AMENDMENT NO. 1 APPROVED ON 1981-07-28.

SLS 413:1977 SPECIFICATION FOR STAINLESS STEEL  
SPOONS AND FORKS

FIGURE 2 - Spoons

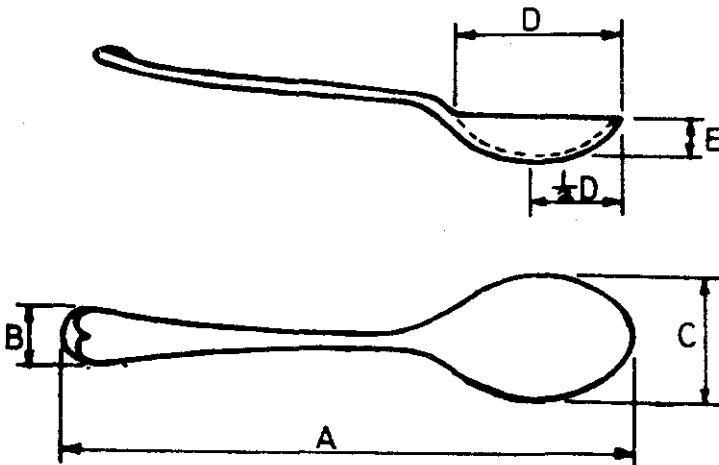
Page 9 Fig. 2 - Spoons

Delete the existing figure and substitute the following figure.

FIGURE 3 - Fruit spoon

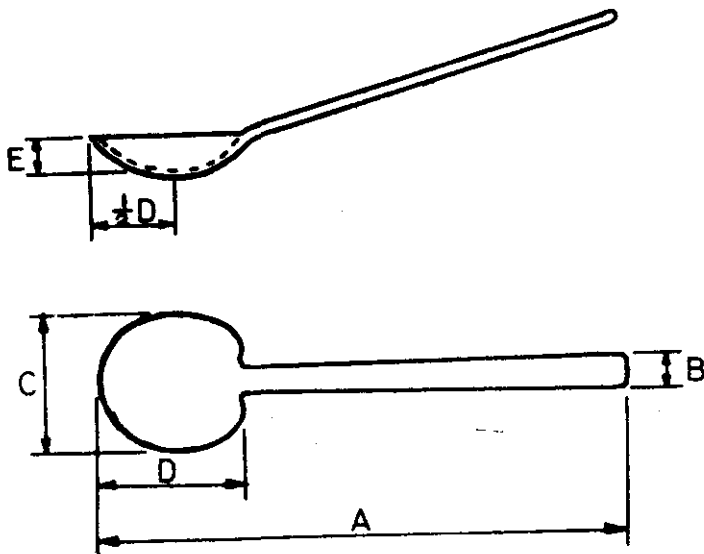
Fig. 3 - Fruit spoon

Delete the existing figure and substitute the following figure.

FIGURE 4 - Soup spoon

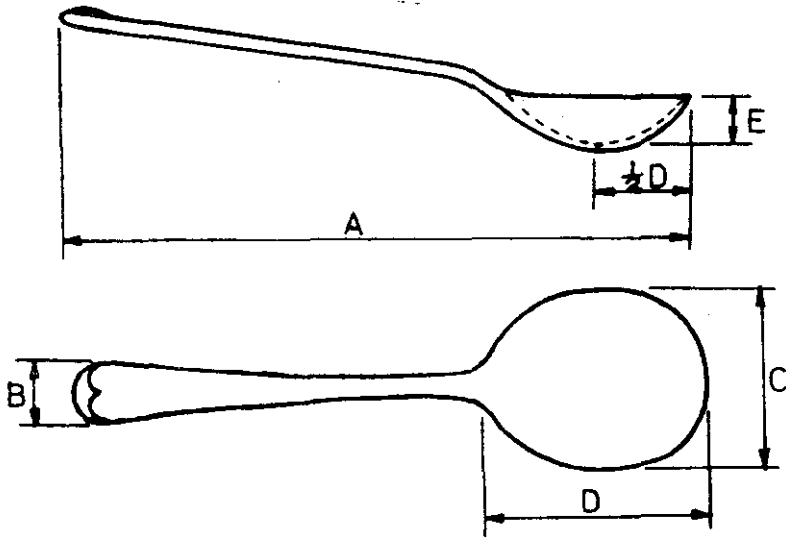
Page 10 Fig. 4 - Soup spoon

Delete the existing figure and substitute the following figure.

FIGURE 5 - Fork

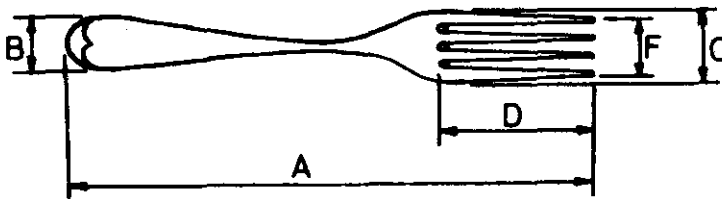
Fig. 5 - Fork

Delete the existing figure and substitute the following figure.

FIGURE 6 - Fish fork

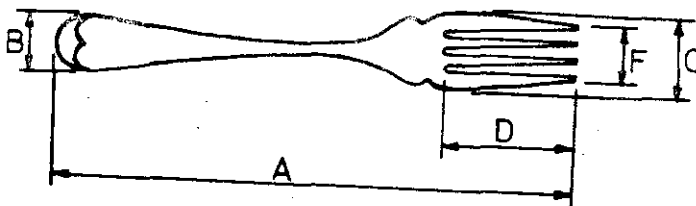
Fig. 6 - Fish fork

Delete the existing figure and substitute the following figure.
